Morrill's Crossing

Application Review Correspondence

RE: Truffic Comments on the Morrill's Crossing Proposed Mixed Use Development - Portland, Maine; CME Project No. 04-147.

Response to Comments

Comment 19

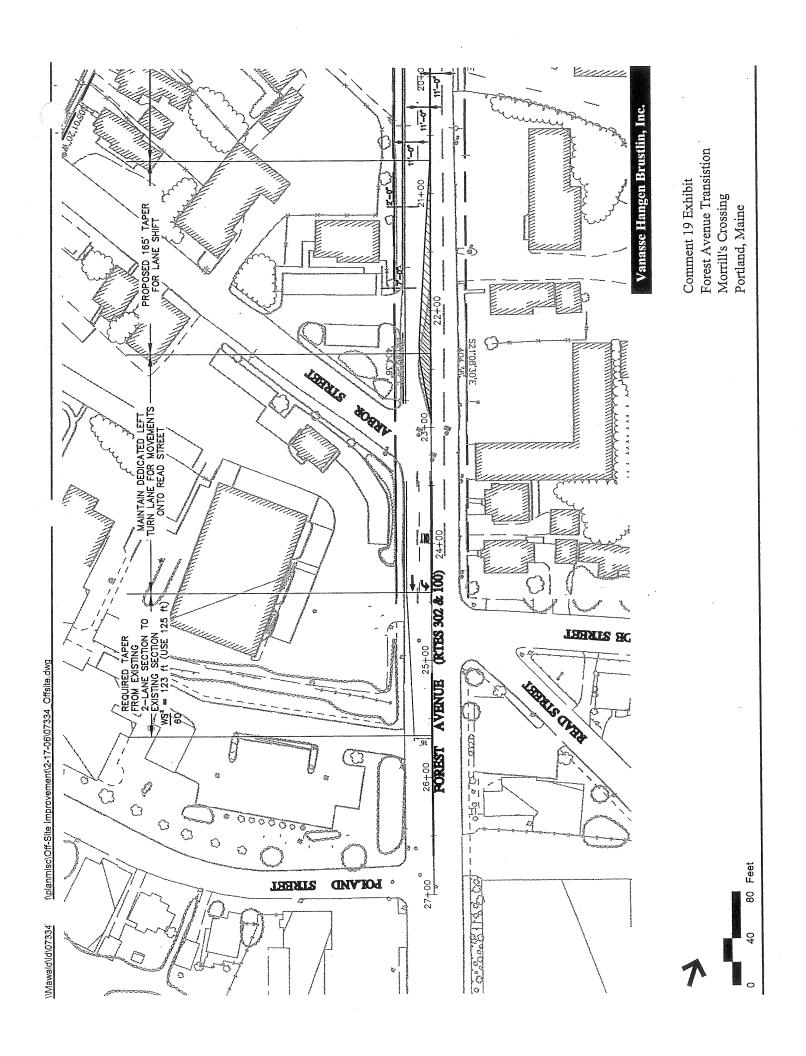
See attached roadway plans showing the transitions along Forest Avenue inbound from two-lanes down to one-lane.

Boxing Club
Building Areas Comparison
Morrill's Crossing
Portland, Maine

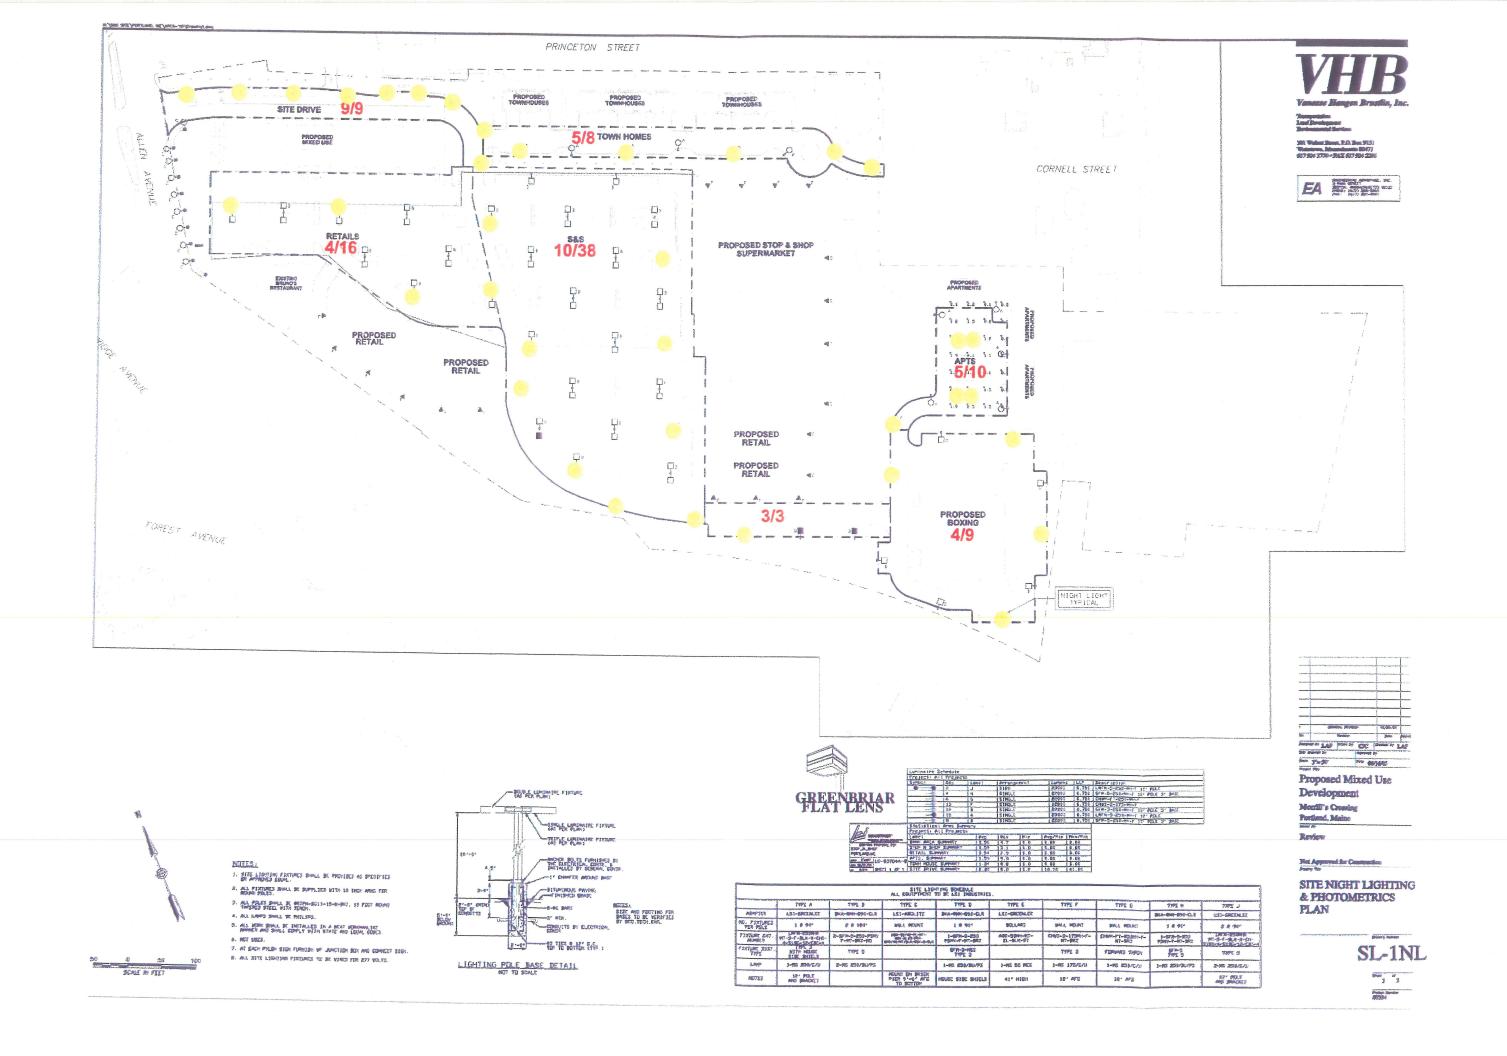
PROPOSED BOXING CLUB - SITE PLANS 7/1/05

REVISED BOXING CLUB - 2/24/06

#3 – Allen Avenue Apartments Conceptual Driveway Layout

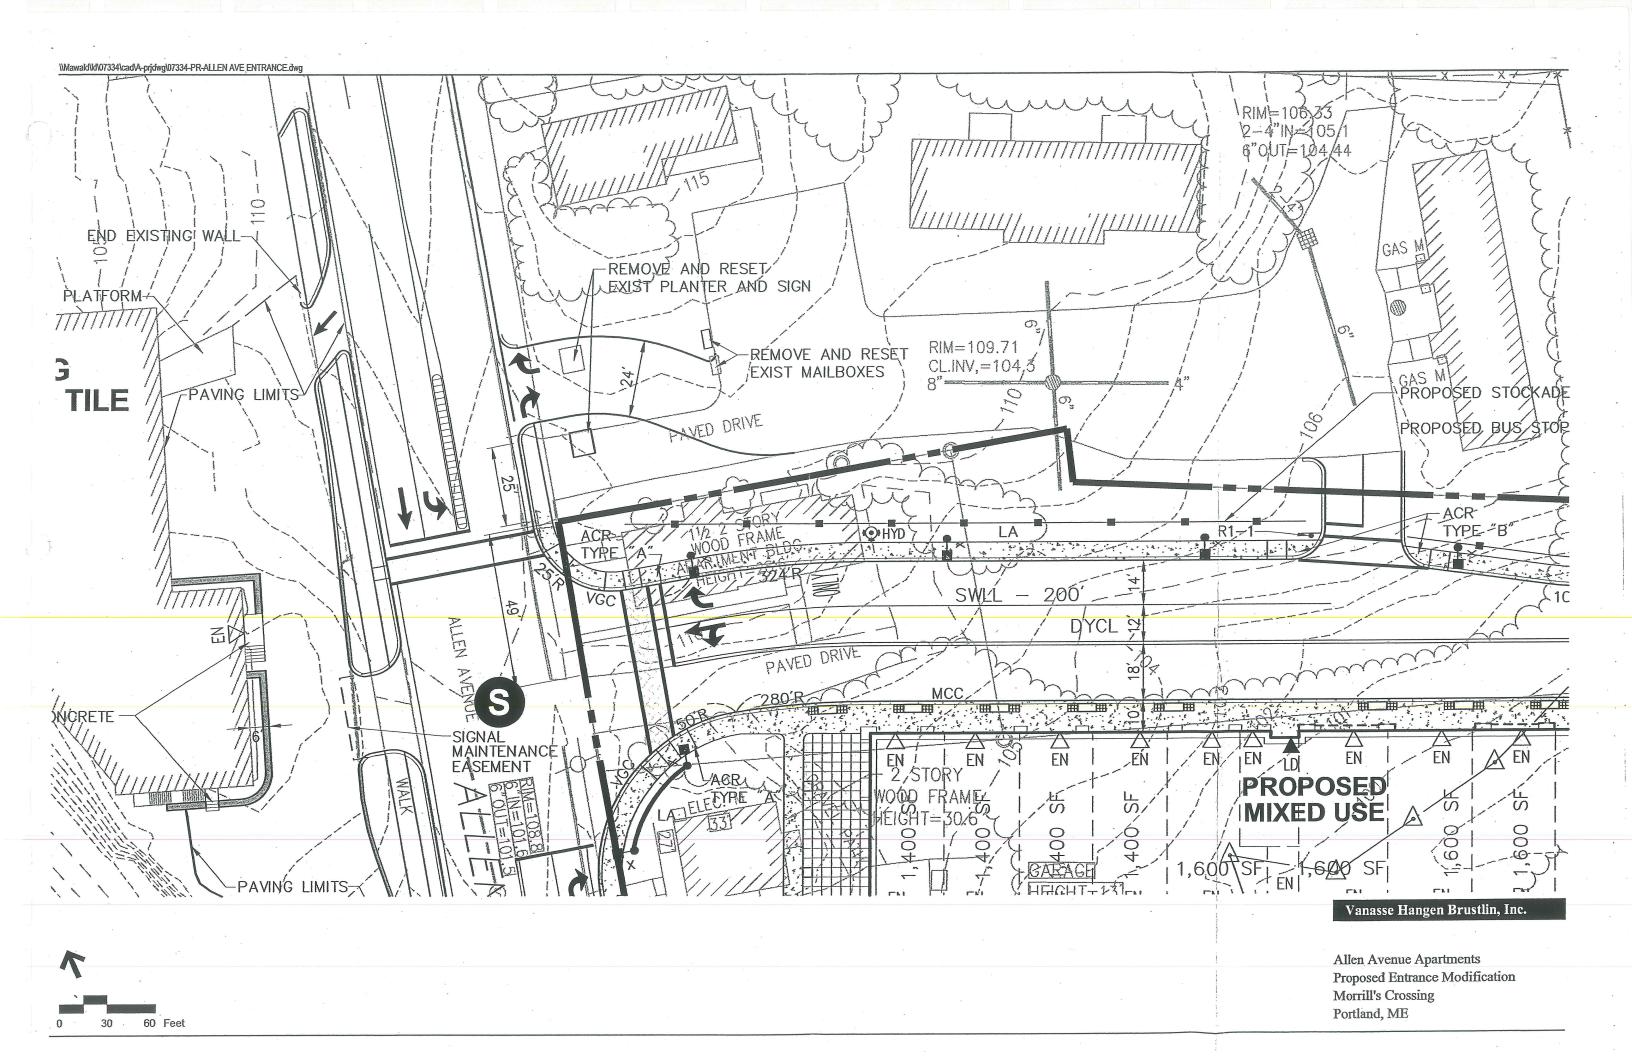
The applicant is currently working with the owner of the Allen Avenue Apartments complex to determine the optimal driveway access and egress options for their site while also integrating it within the proposed site plan. Given MaineDOTs concern about the location of the driveway in proximity to the project's main site driveway, VHB has prepared an exhibit showing the driveway relocated to the north, providing additional separation from the signalized driveway.

This proposal calls for the restriction of left-turns into and out of the Allen Avenue Apartments driveway along Allen Avenue and shifts the driveway approximately 25 feet further to the north.
